City of Phoenix PLANNING AND DEVELOPMENT DEPARTMENT

Staff Report Z-6-22-2 April 29, 2022

Proposed Use: Single-family and multifamily residential

Conceptual Site Plan, Source: ABLA Studio

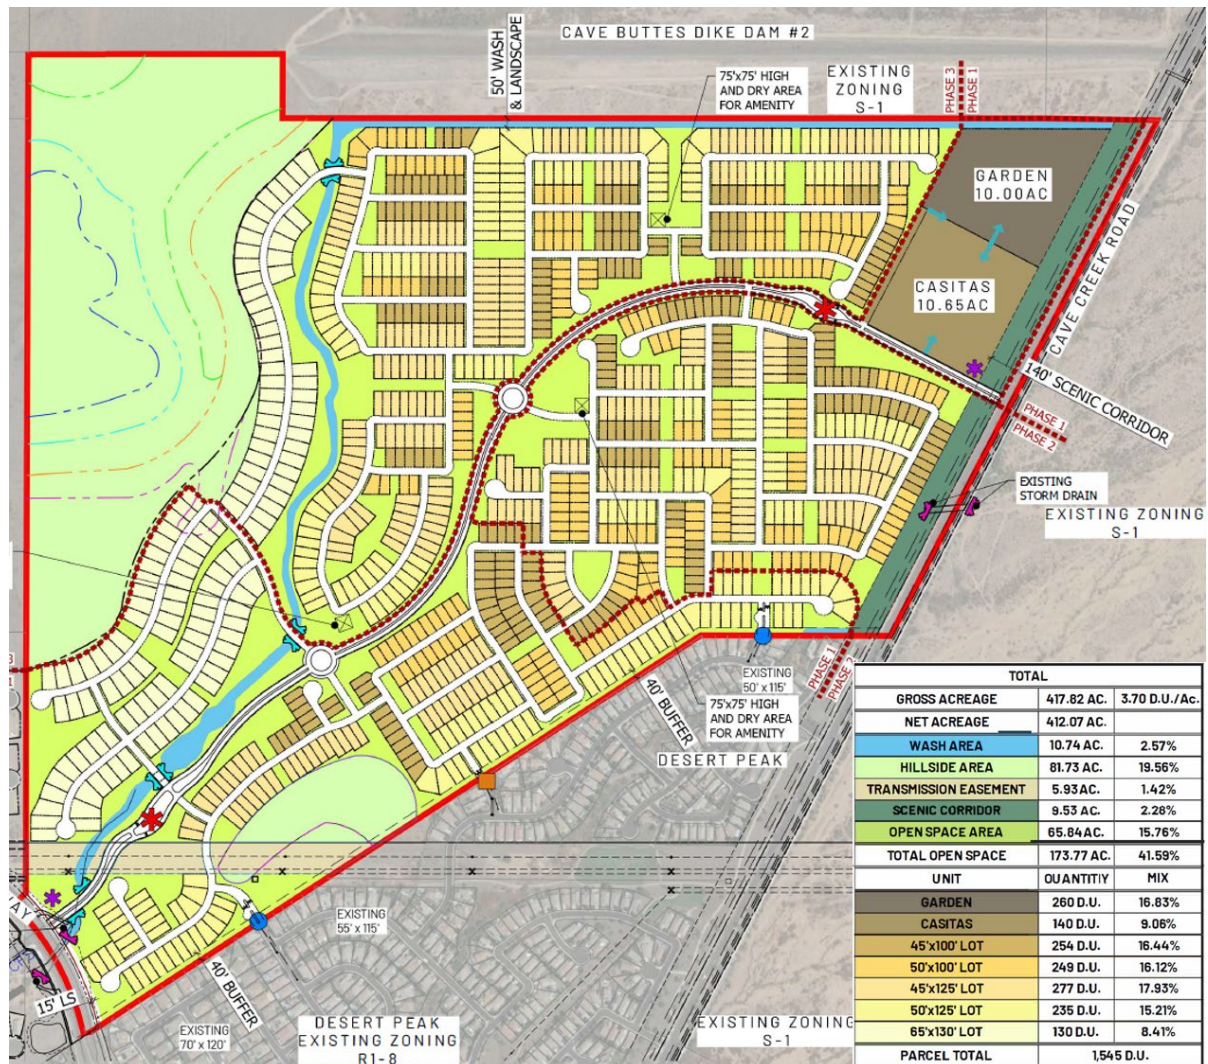
Staff does not recommend general conformance to the site plan, as this is a large development, and the specific layout of lots and streets could change during the subdivision and site plan review process. Staff is recommending several stipulations that require certain aspects of the site plan to be maintained, as described below.

The conceptual site plan includes a 74.82-acre hillside area in the northwest portion of the site, which is intended to be conveyed to the City of Phoenix Parks and Recreation Department for development of a future park or mountain preserve. This conveyance is consistent with the General Plan Land Use designation of Future Parks/Open Space or 1 dwelling unit per acre for the northwest hillside area. The developer also intends to provide public access to the preserve area through two access points within the subdivision, including a trail network and the possibility of a

public parking area to ensure the public has access to the preserve. These aspects of the plan are incorporated in Stipulation Nos. 1 and 2.

Staff recommends the following site plan elements to be incorporated:

- A minimum 140-foot landscape setback along Cave Creek Road, consistent with the designation as a scenic corridor (Stipulation No. 3);
- Enhanced landscaping with 70 percent two-inch and 30 percent three-inch caliper trees, planted 20 feet on center and five, five-gallon shrubs per tree within landscape setbacks along Cave Creek Road, Desert Peak Parkway and the perimeter setbacks of the R-2 and R-3A zoned areas (Stipulation No. 4);

- Minimum 15 percent open space (after the dedication of the hillside area) provided within the R1-10 zoned area (Stipulation No. 25);
- Minimum 10 percent open space provided within each of the R-2 and R-3A zoned areas (Stipulation Nos. 28 and 32);

- A minimum of two active and three passive open space areas provided within the R1-10 zoned area (Stipulation No. 26);
- A minimum of five amenities provided within the open space areas for the R-2 and R-3A zoned areas (Stipulation Nos. 29 and 33).

Overall Trails Exhibit, Source: ABLA Studio

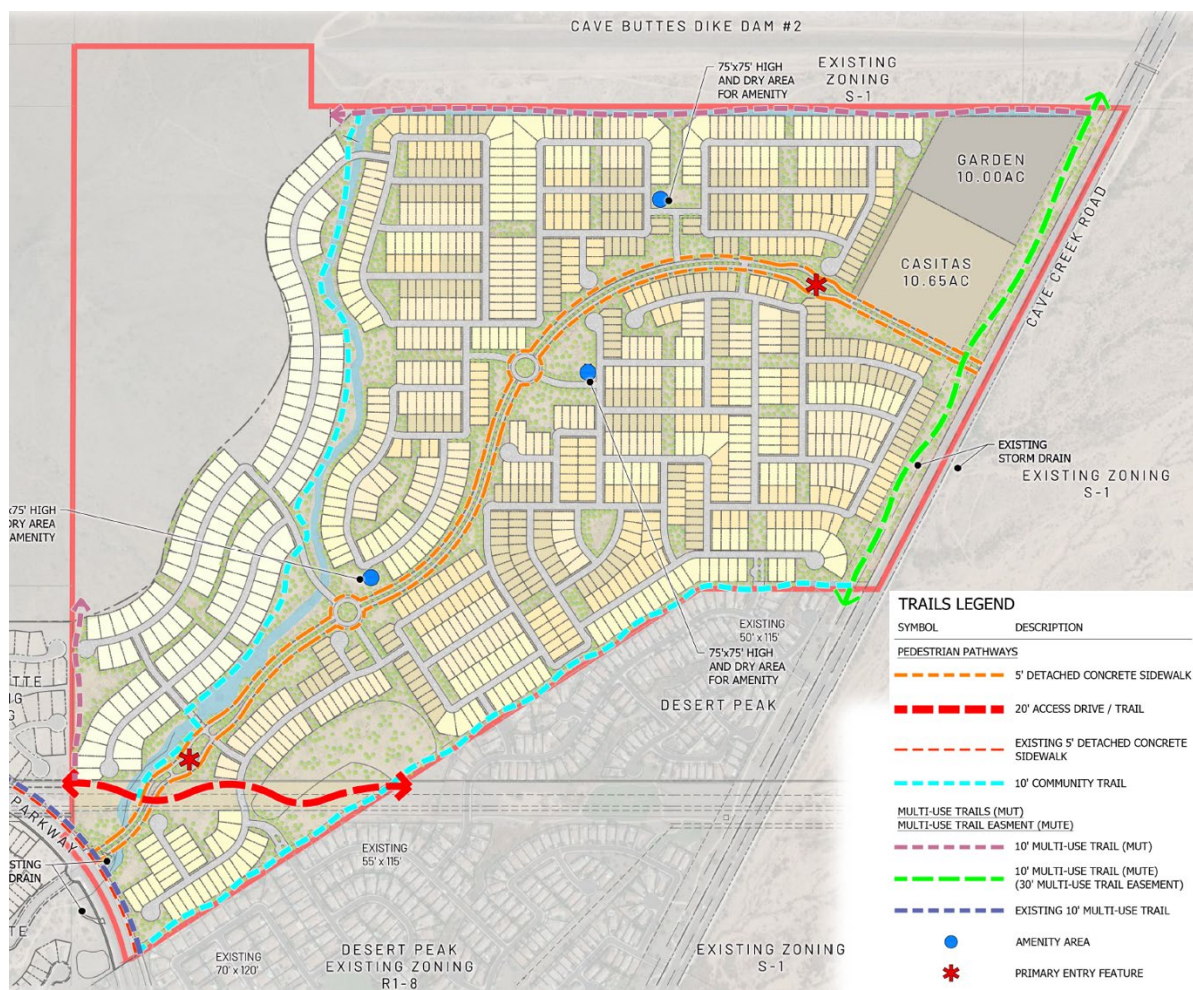
The applicant has submitted an Overall Trails Exhibit, which depicts the location of a proposed trail network within and surrounding the site. It includes multi-use trails along the entire frontages of Cave Creek Road and Desert Peak Parkway and a combination of multi-use trails, community trails, and detached sidewalks through the site connecting the two frontages along three separate paths. The development does not intend to be closed to pedestrians. Public access easements will be required to meet the public access requirement for the access points to the preserve. It is expected that the internal multi-use trails will contain easements sufficient to fulfill this requirement, but the plan for access will be finalized at a later date in consultation with the Parks and Recreation Department, per Stipulation No. 2.

Staff recommends the following elements of the Overall Trails Exhibit to be incorporated into the development:

- A 10-foot-wide multi-use trail (MUT) and 30-foot-wide multi-use trail easement (MUTE) shall be provided along both perimeter frontages (Stipulation No. 6);
- Ten-foot-wide community trails and multi-use trails shall be provided within the development, where indicated on the plan (Stipulation No. 7);
- A detached sidewalk shall be provided along the primary roadway through the development, as indicated on the plan, including two-inch caliper shade trees planted 25 feet on center planted between the sidewalk and the back of the curb (Stipulation No. 10).

Conceptual Single-Family Building Elevations, Source: DR Horton

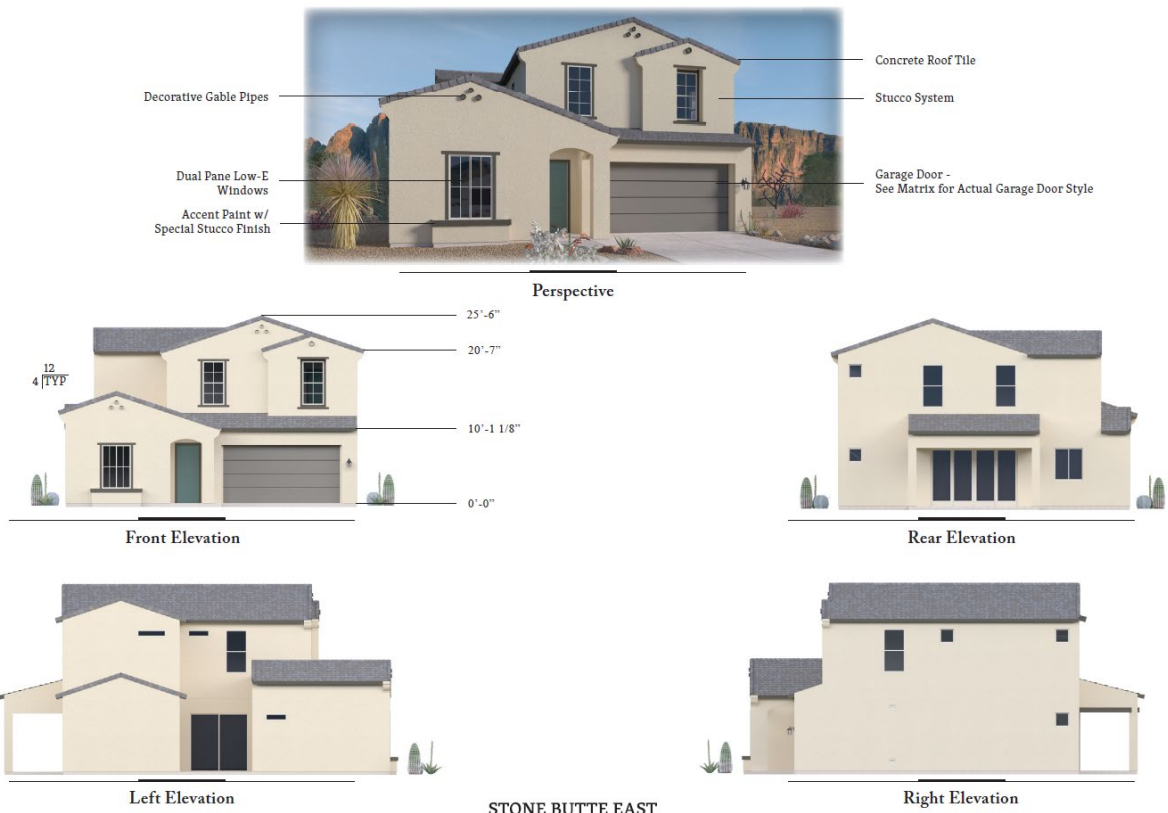
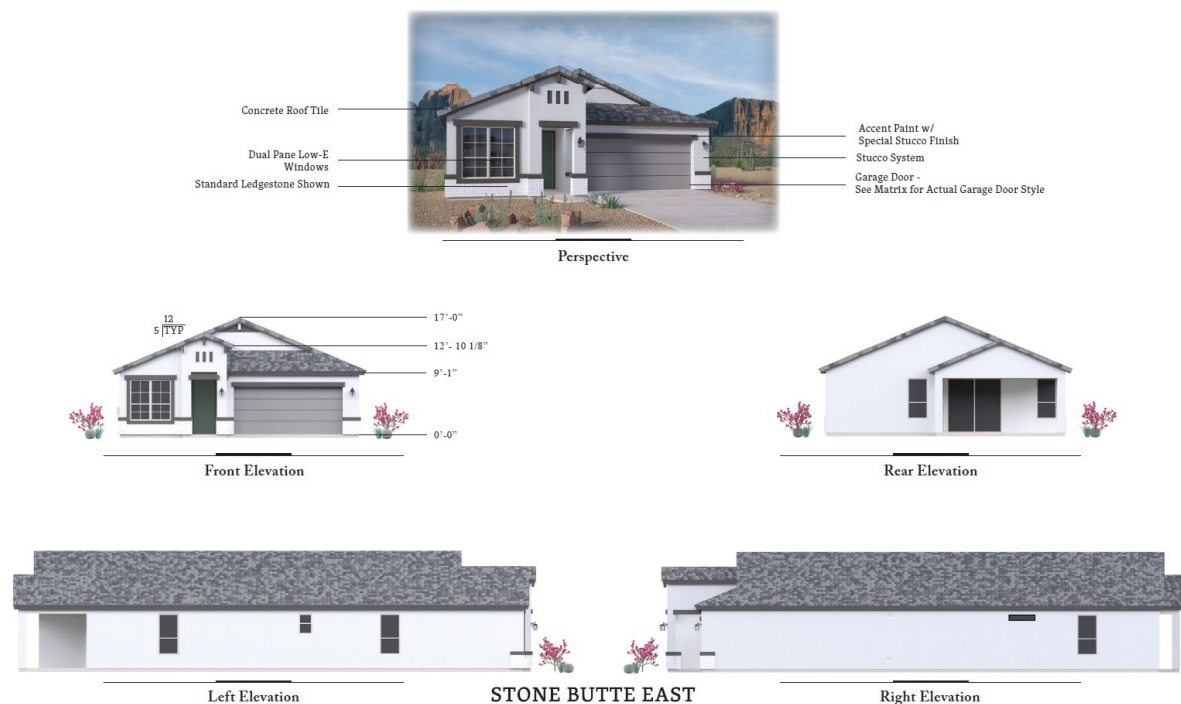
The conceptual building elevations for the single-family homes depict one- and two-story homes with a variety of architectural styles and variation in colors, textures, and facades. Staff recommends enhancing the four-sided architectural component by requiring architectural detailing to the windows on all sides of the buildings (Stipulation No. 24).

24. Building elevations shall depict architectural detailing applied to windows on all sides of the homes, as approved by the Planning and Development Department.
25. A minimum of 15 percent of the gross site area for the R1-10 zoned portion of the site, after dedication of the hillside area to the city, shall be retained as open space, including washes and internal hillside areas, as approved by the Planning and Development Department. This requirement shall not be applied to individual phases of the overall development.
26. A minimum of two distinct active open space areas and a minimum of three passive open space areas shall be provided within the overall R1-10 zoned area, as approved by the Planning and Development Department.
